**ADDENDUM No. 1**

January 10, 2020

224209

**Gunstock Mountain Resort  
Culvert Repair & Extension**

# Gunstock Culvert

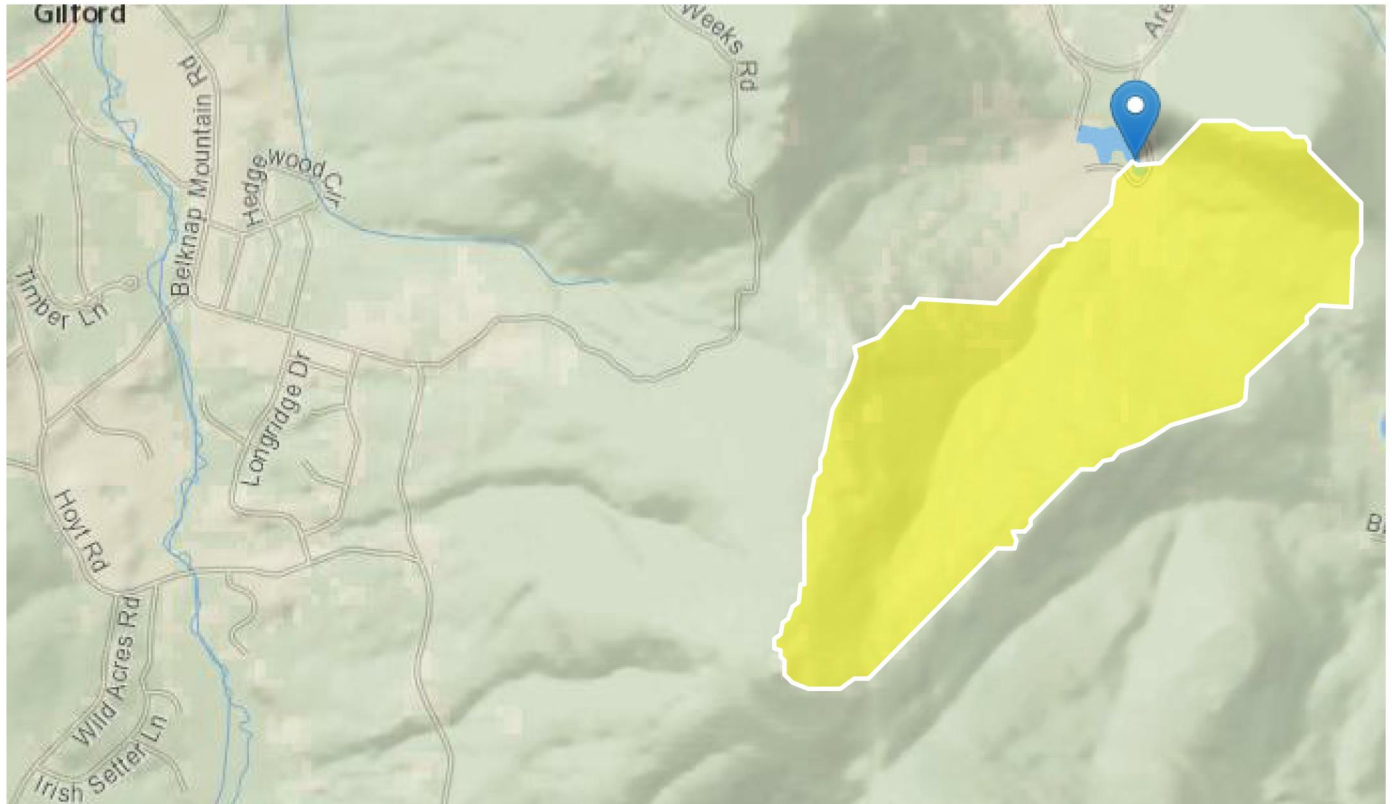
- Q: Do you have hydraulic information about the stream flows?  
A: A copy of streamstats report is attached to this addendum which may be used to estimate stream flows.
